ADDENDUM NO. 1

PROJECT NAME: Nebraska Union First Floor Selective Refurbishment
UNL PROJECT NUMBER: C026P336
BID INVITATION NUMBER: 2209-13-7200

CONSULTANT: Holland Basham Architects
ADDRESS: 119 S. 49th Ave, Omaha, NE

DATE OF ISSUANCE: 20 August 2013
DATE OF BID OPENING: 27 August 2013

2 ENLARGED REFLECTED CEILING PLAN
A3.0
0' 5' 10' 15' 20'

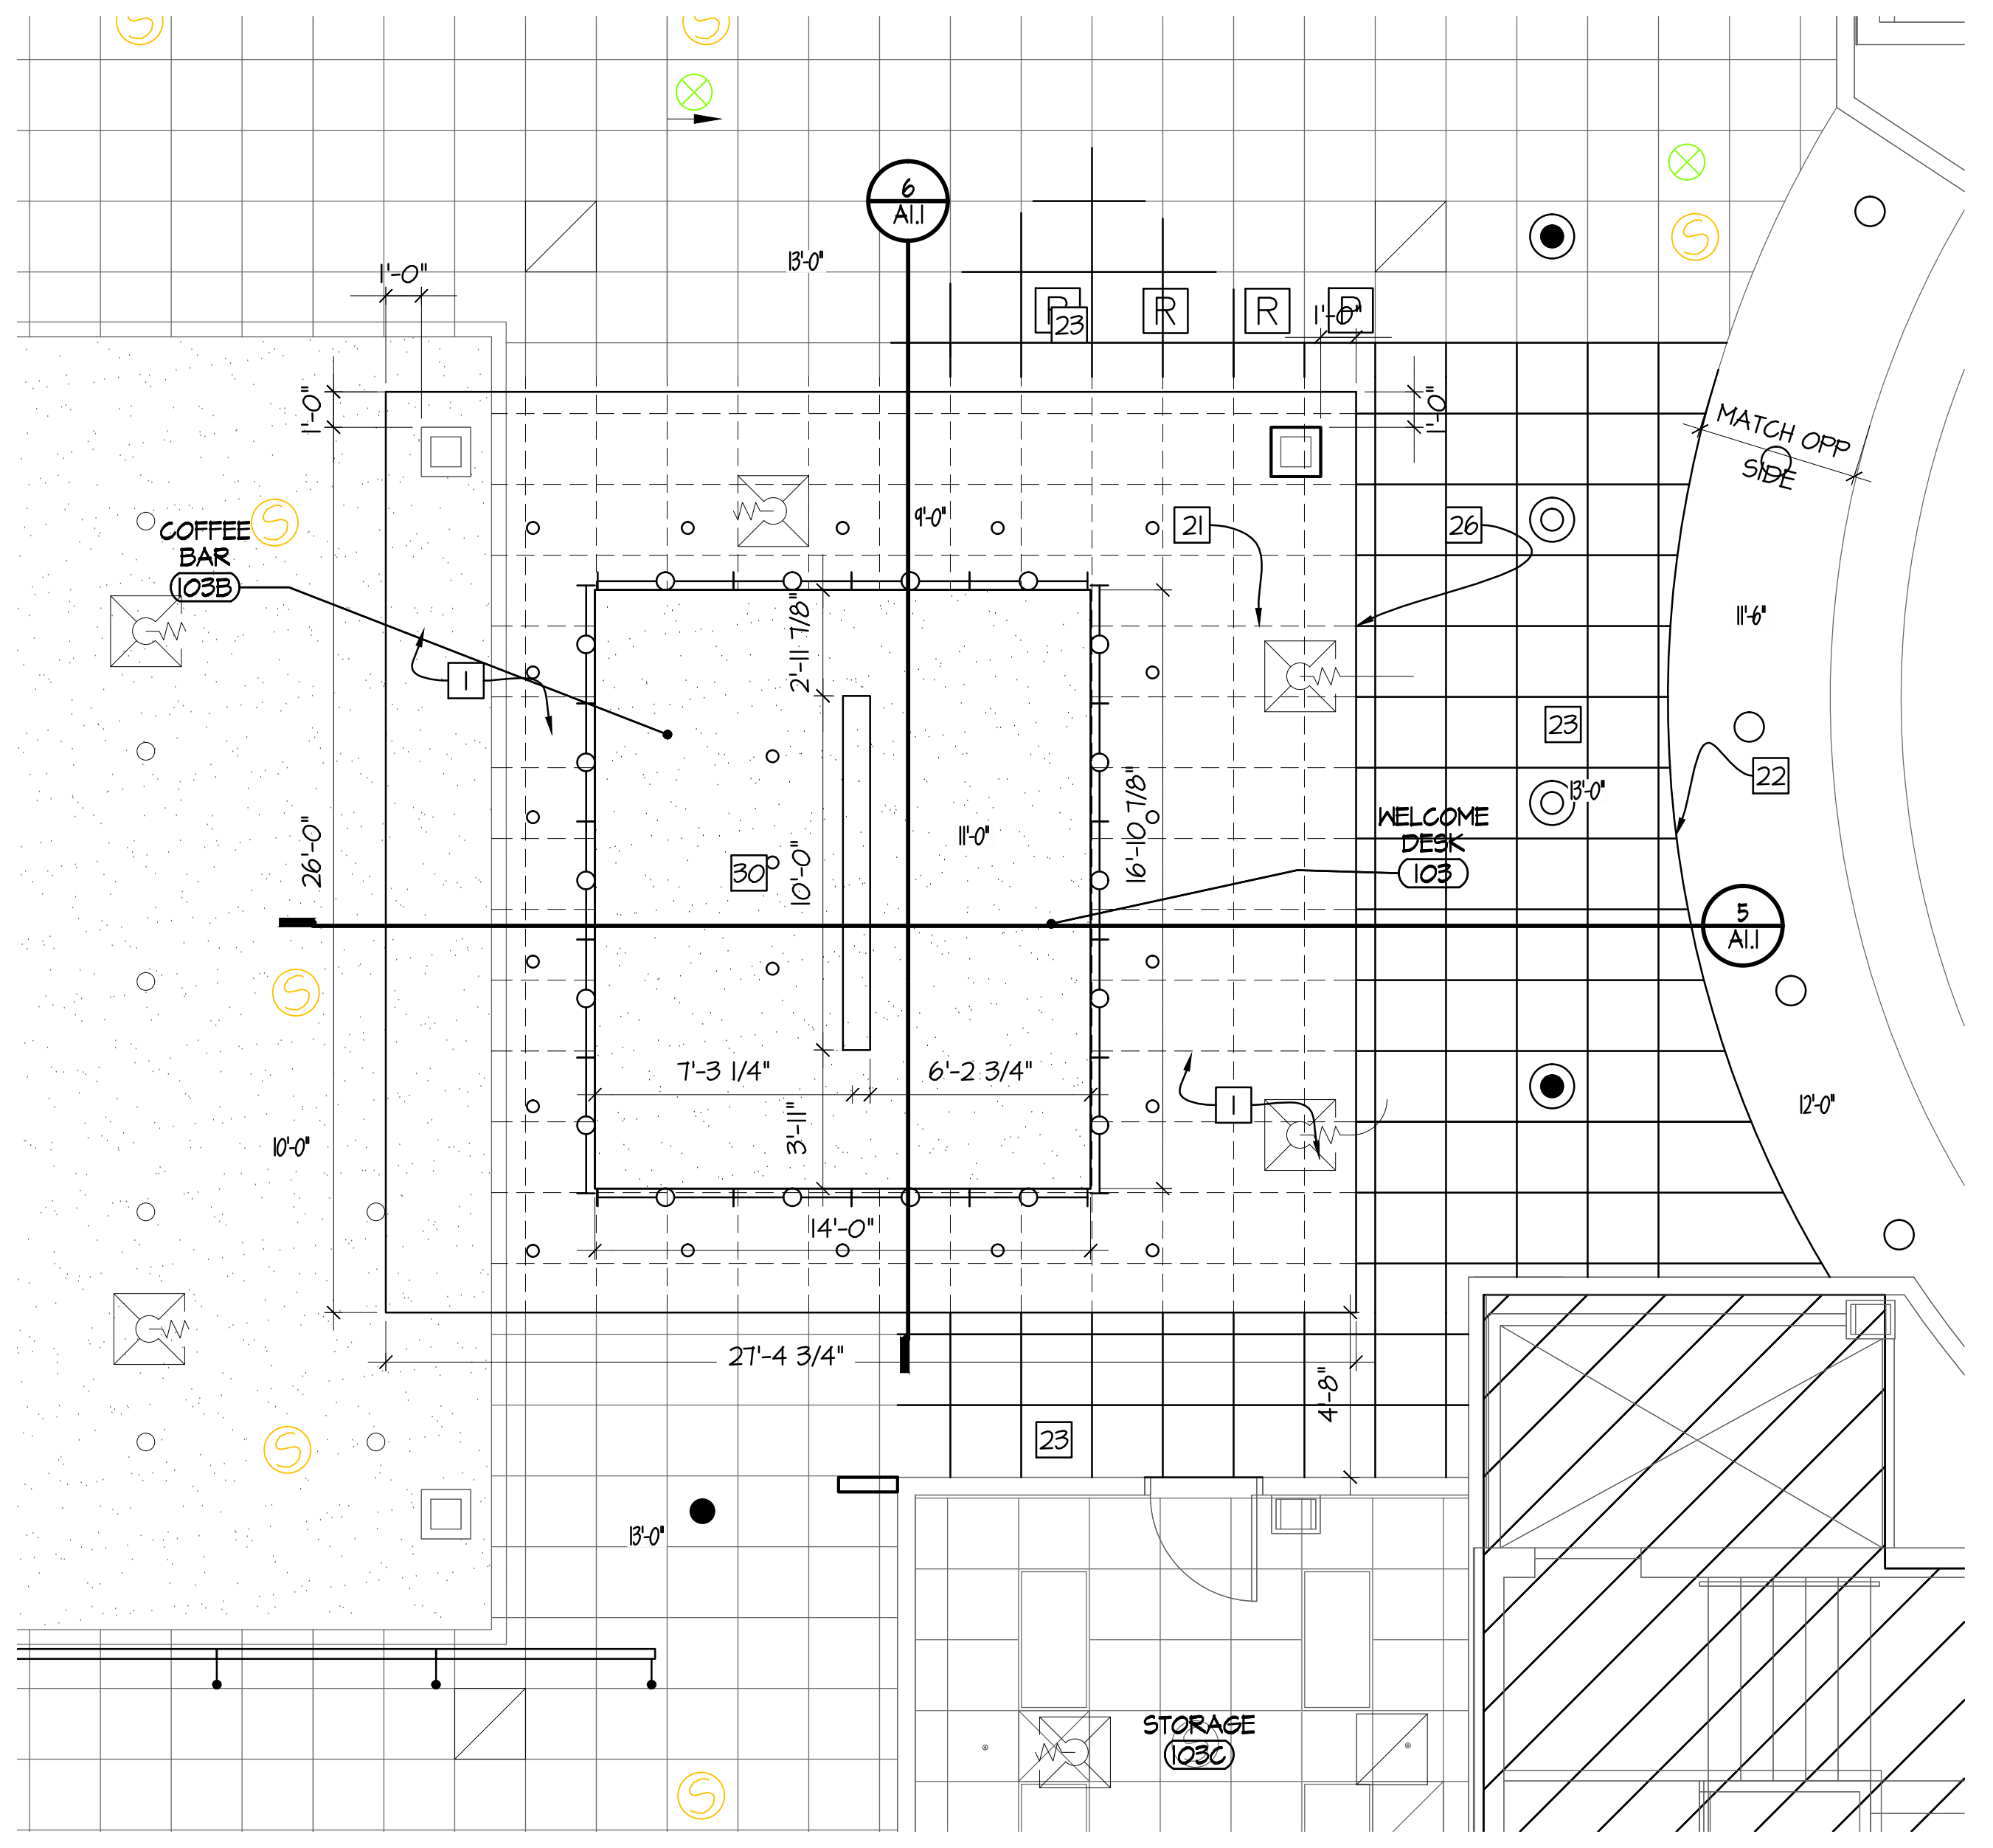
1. Delete the following:
 - a. Keyed Notes: numbers 14 and 25
 - b. Corridor 126: number 13 and 14

- c. Section cut 9/A4.0
 - d. Lobby 128: number 15
 - e. Vestibule 129: number 15
 - f. Enlarged Reflected Ceiling plan: access panel
2. Modify the following:
 - a. Lobby 128: lighting change to existing.
 - b. Vestibule 129: lighting change to existing.
 - c. 2/A3.0 Enlarged RFP: Added dimensions for clarification.

9 LIGHT COVE DETAIL
A4.0
0' 1.5' 3' 6'

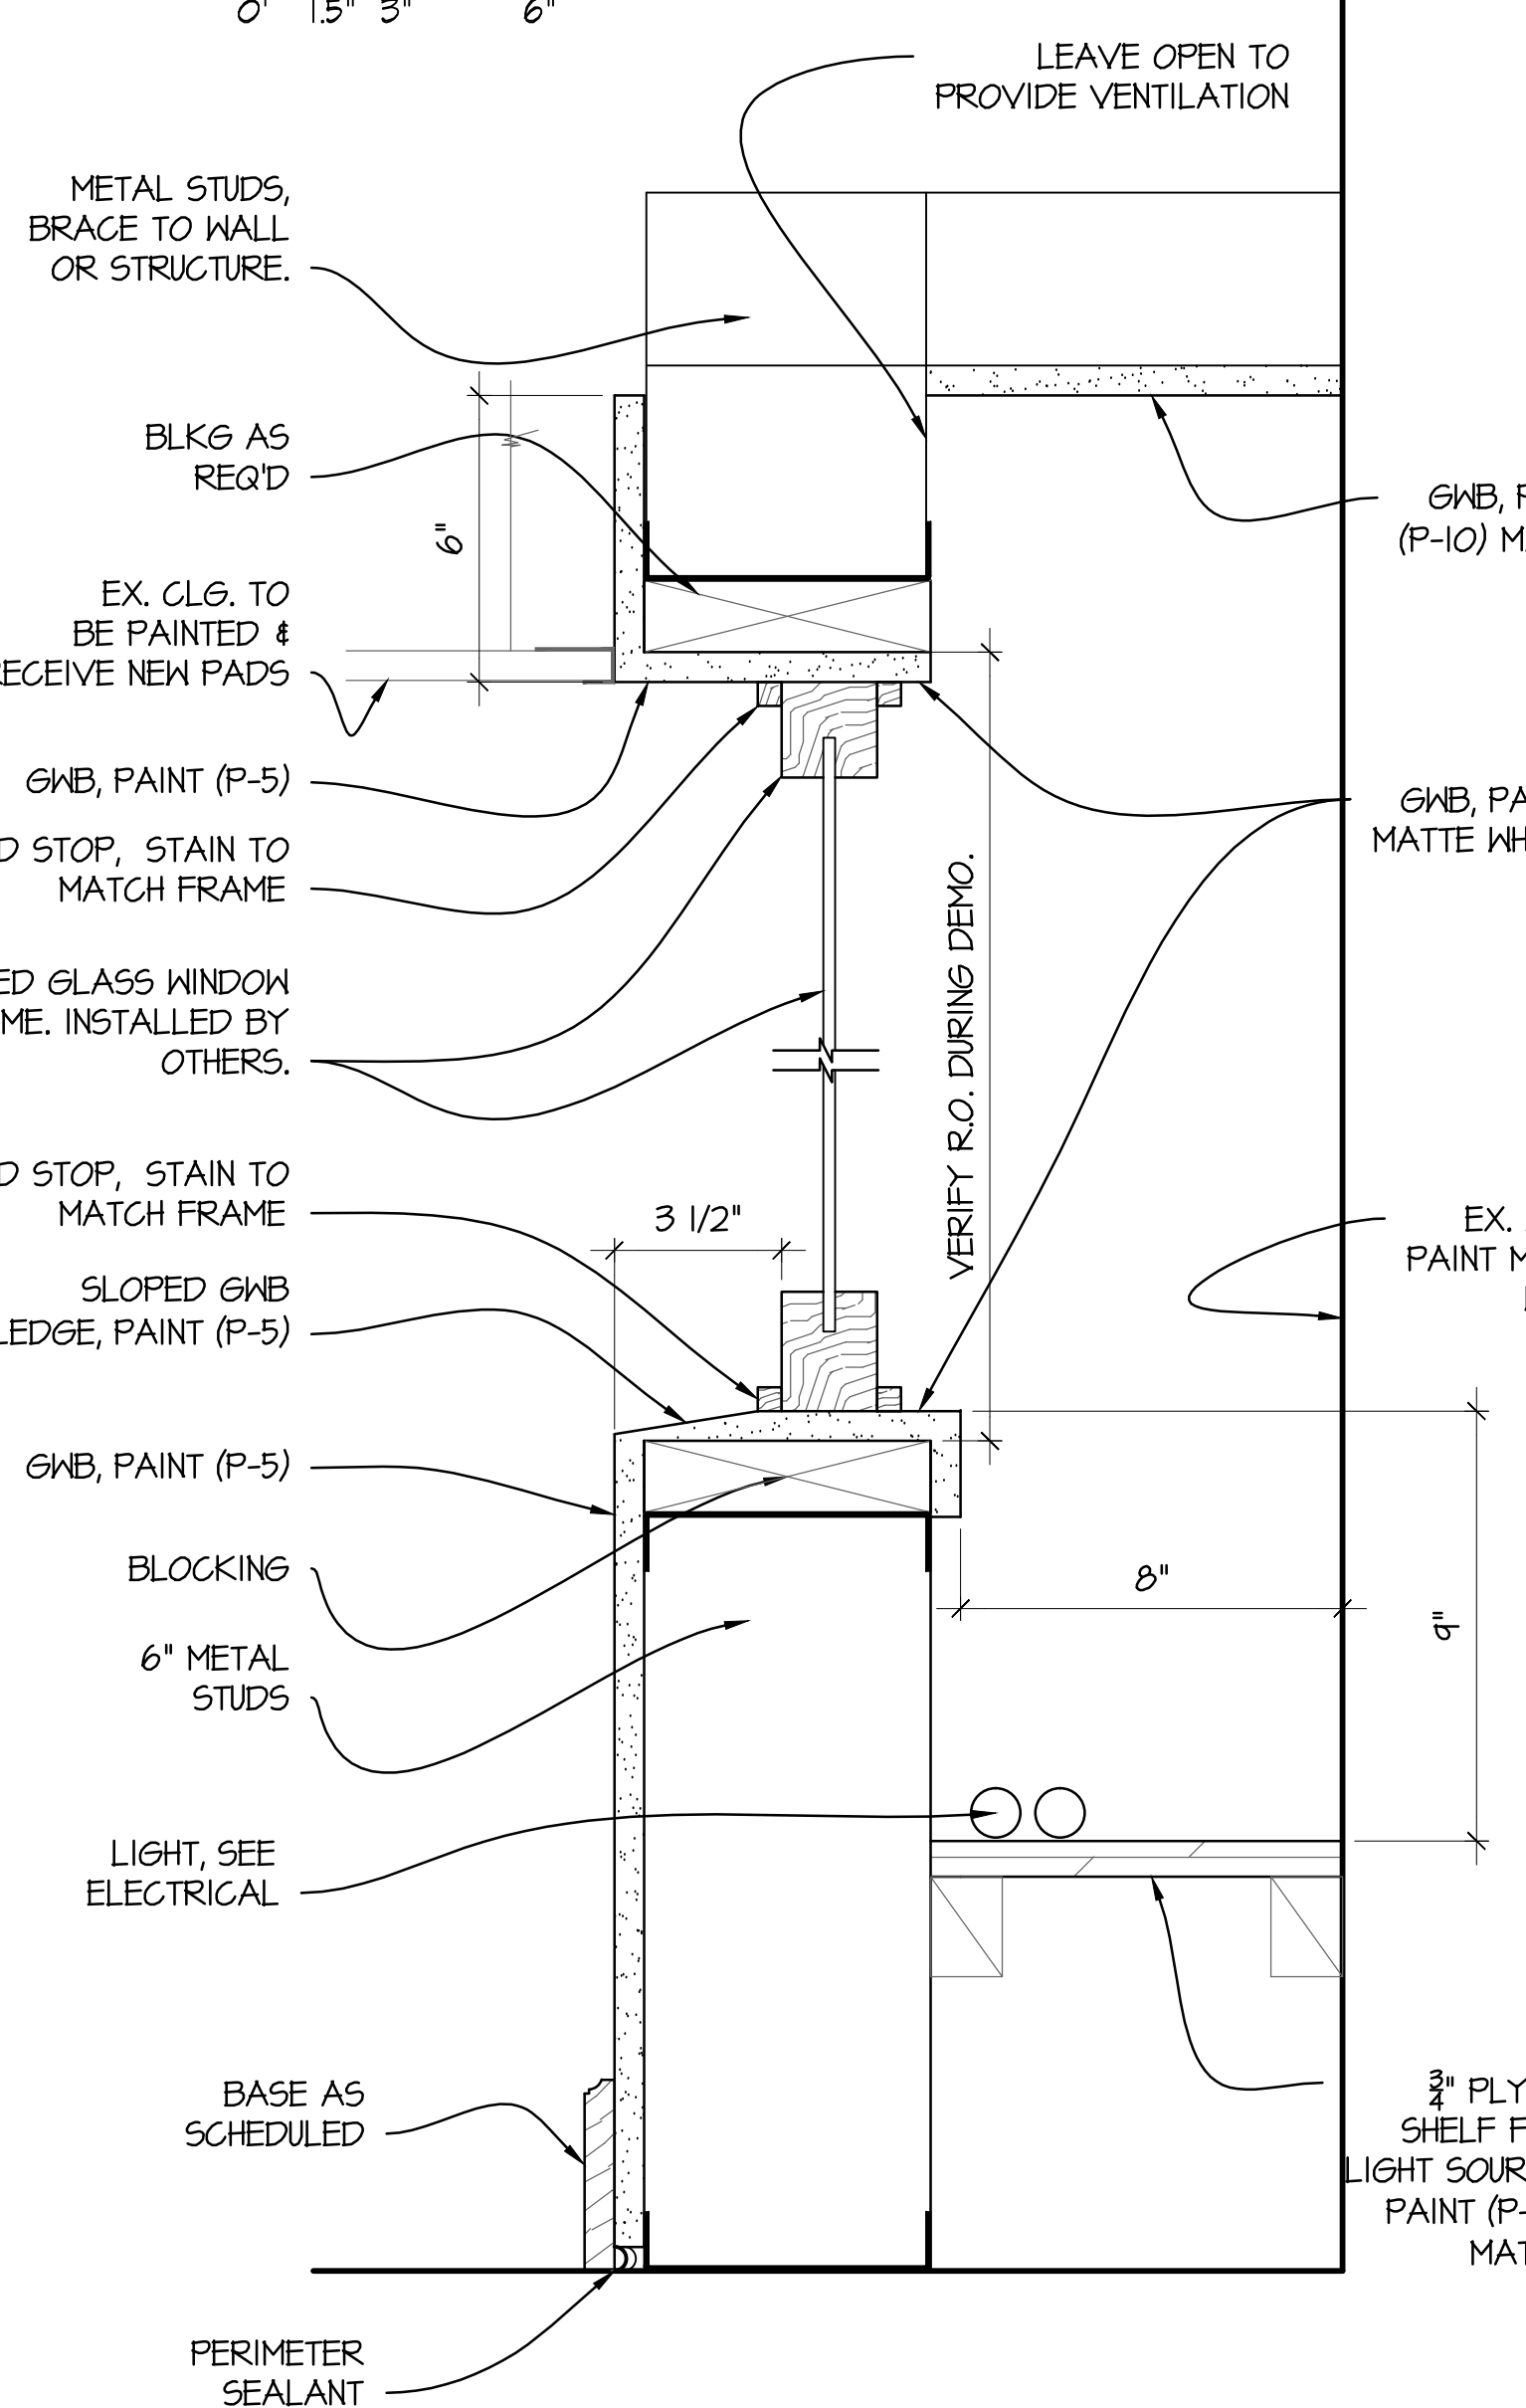
1. Delete the following:
 - a. Detail 9/A4.0

**DOOR SCHEDULE,
DETAILS AND
ROOM FINISH SCHEDULE**

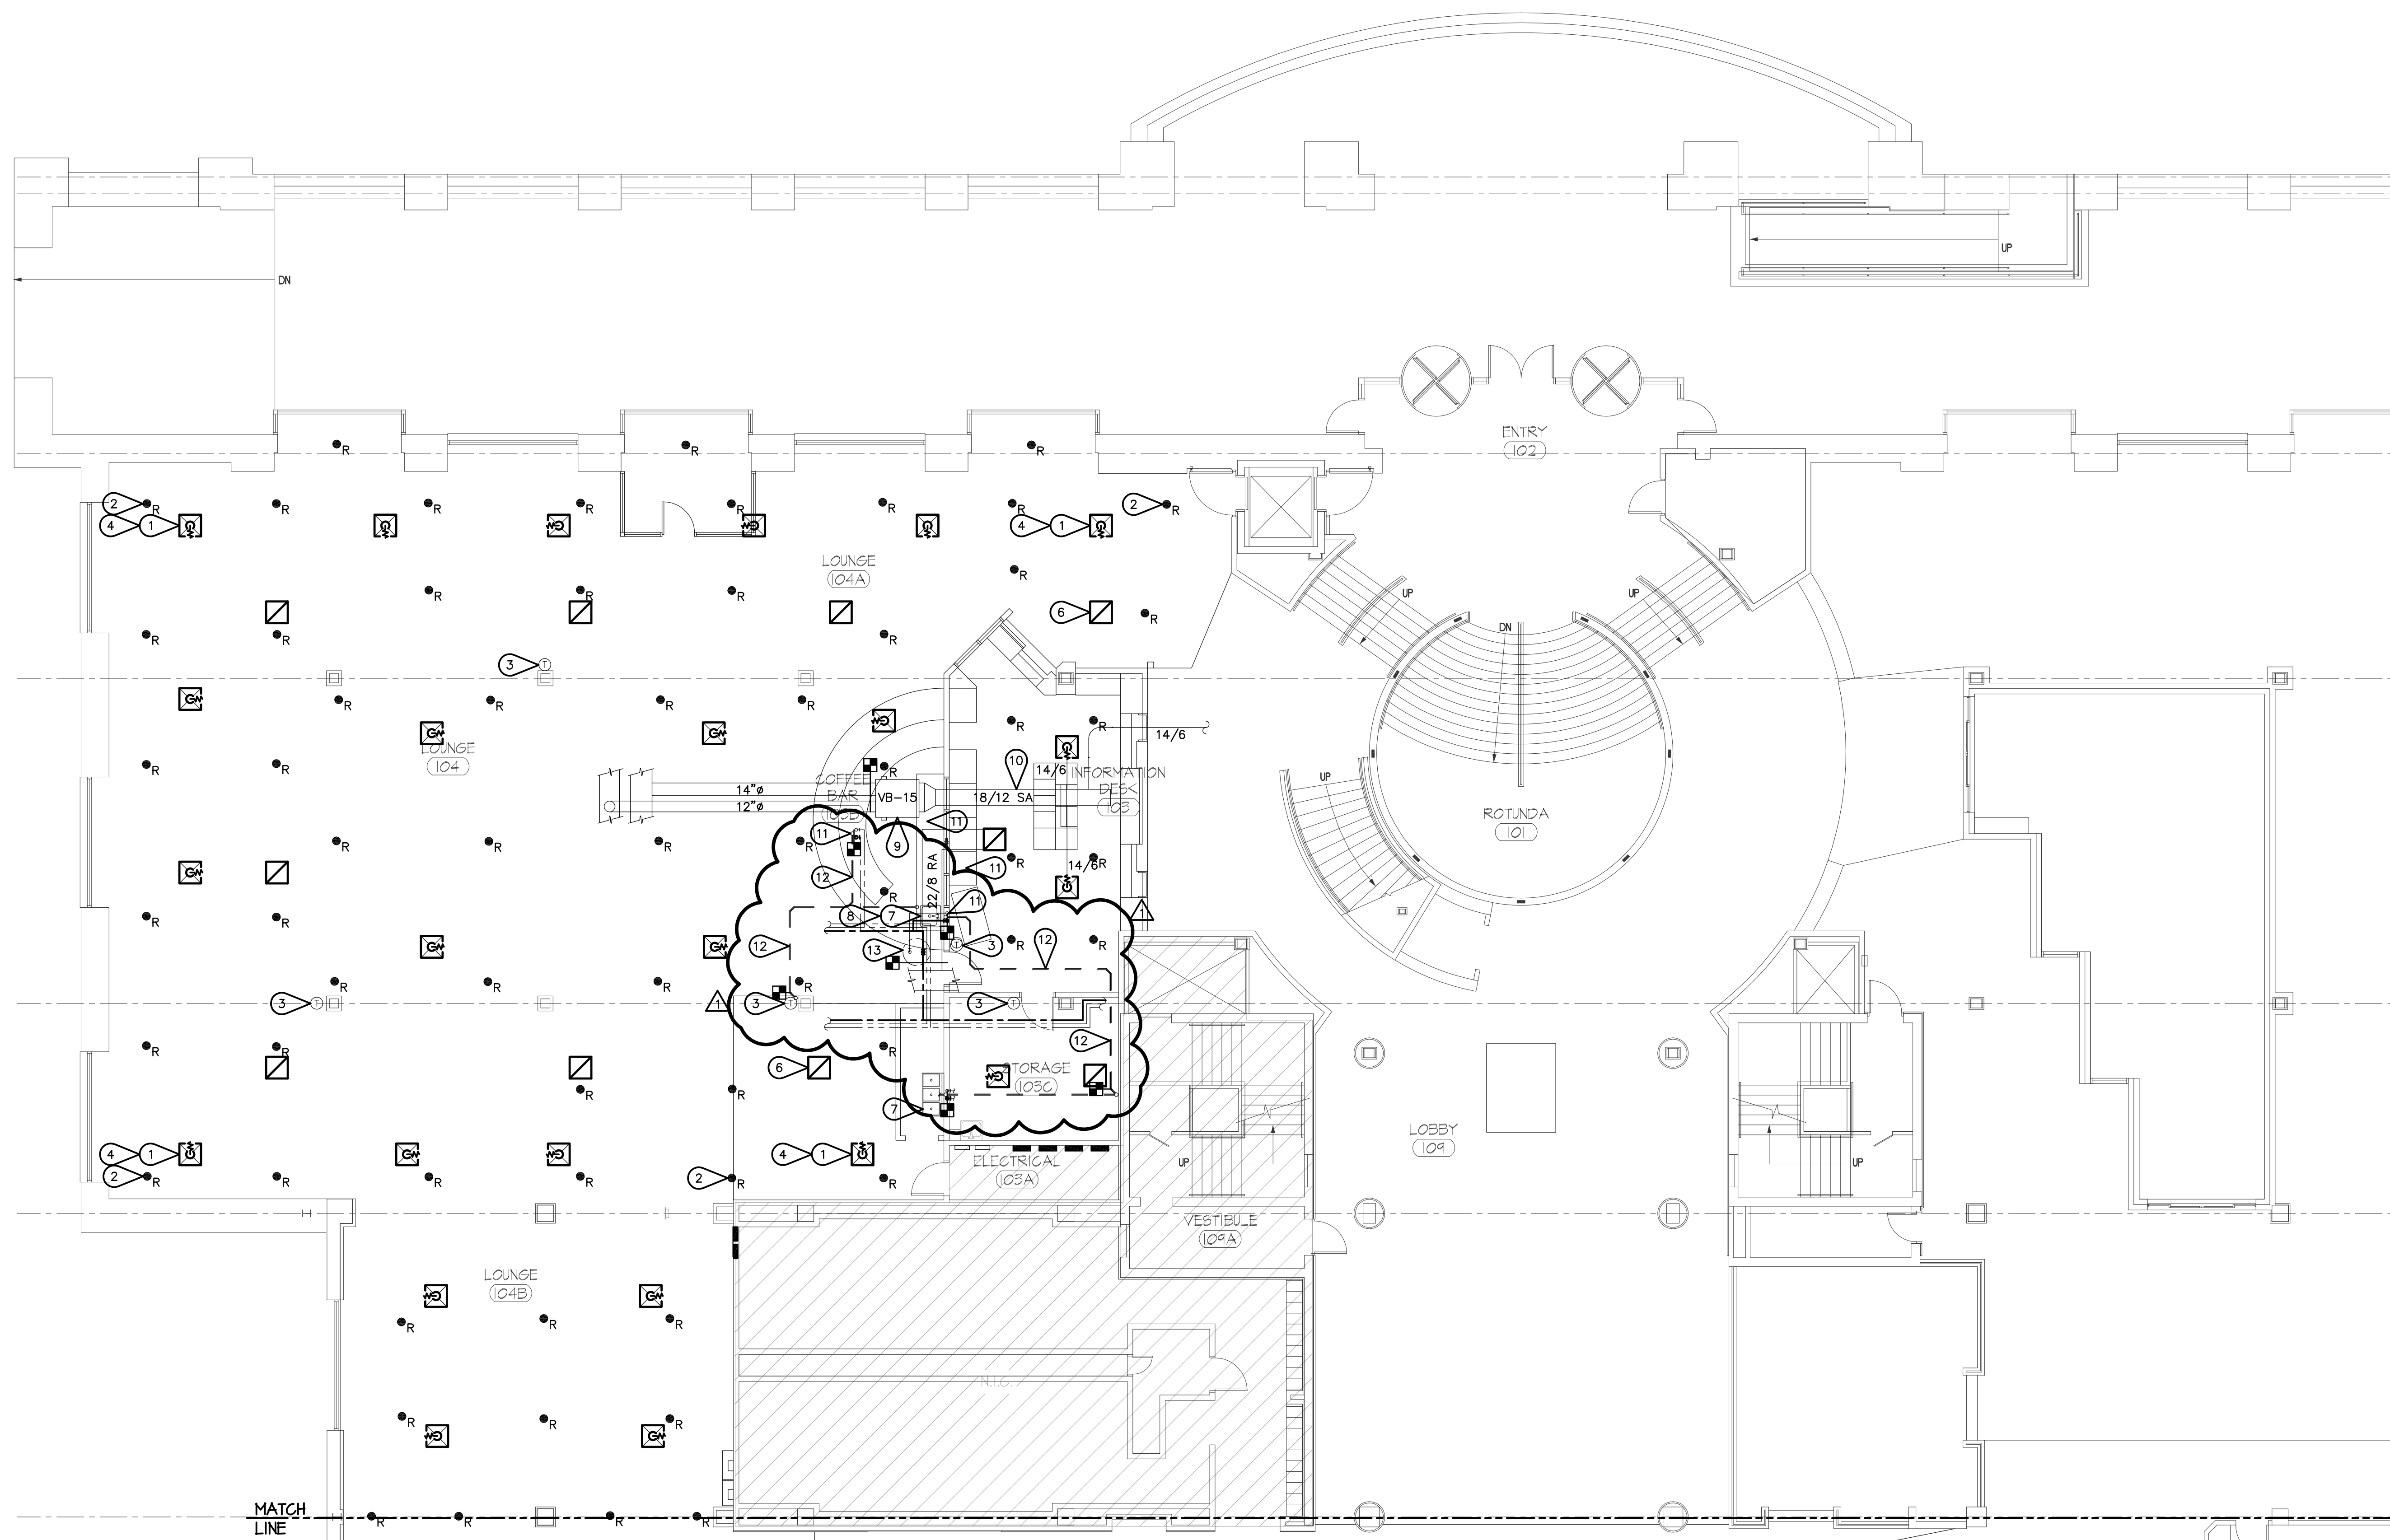
1. Delete the following:
 - a. Door Schedule Notes: numbers 2 & 3
 - b. Room Finish Schedule Notes: numbers 5 & 6
 - c. Room Finish Schedule, Corridor 126: Walls- P-1 and Remarks - note 6
 - d. Room Finish Schedule, Lobby 128: Walls- P-1 and Remarks - note 6
 - e. Room Finish Schedule, Lounge 128A: Base – RB-1, Walls – P-5 and Remarks note 6.
 - f. Room Finish Schedule, Vestibule 129: Walls – P-* and Remarks notes 3 and 5
 - g. Door Types: D2
2. Modify the following:
 - a. Doors 128 A, B and C – existing to remain.
 - b. Doors 129 A, B and C – no work on existing doors.
